The Mass AG was not aware when he filed his appeal brief that the issues in Contention 56 had been resolved.

(Seabrook Station, Units 1 and 2 )

AFFIDAVIT OF ANTHONY M. CALLENDRELLO

ATTACHMENT A

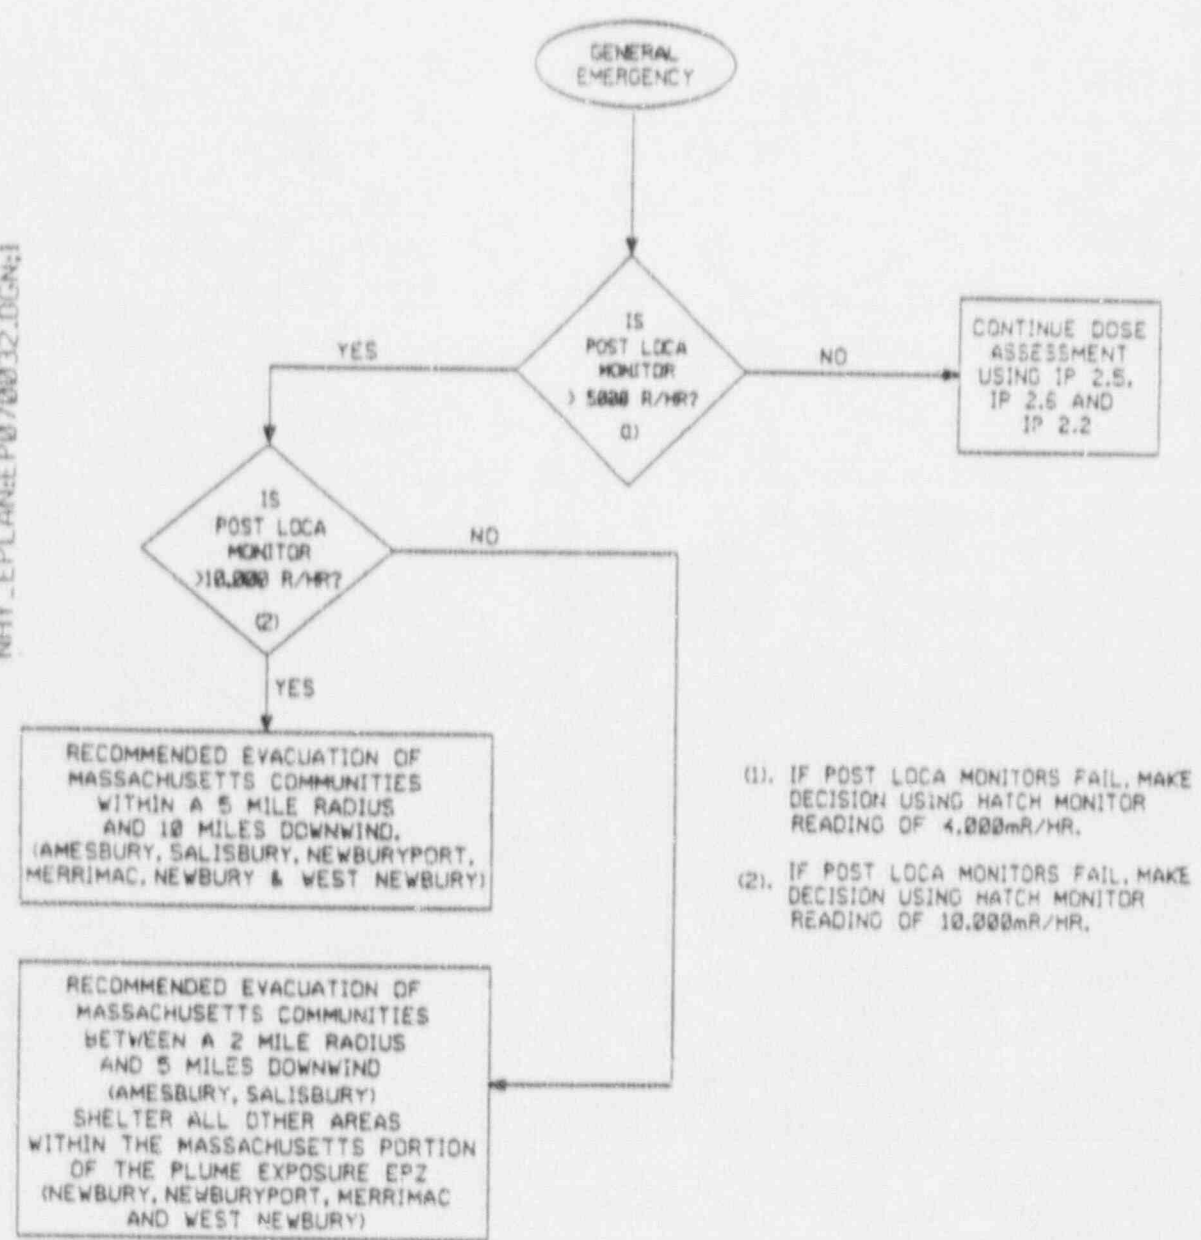
*in place at time of drafting?*
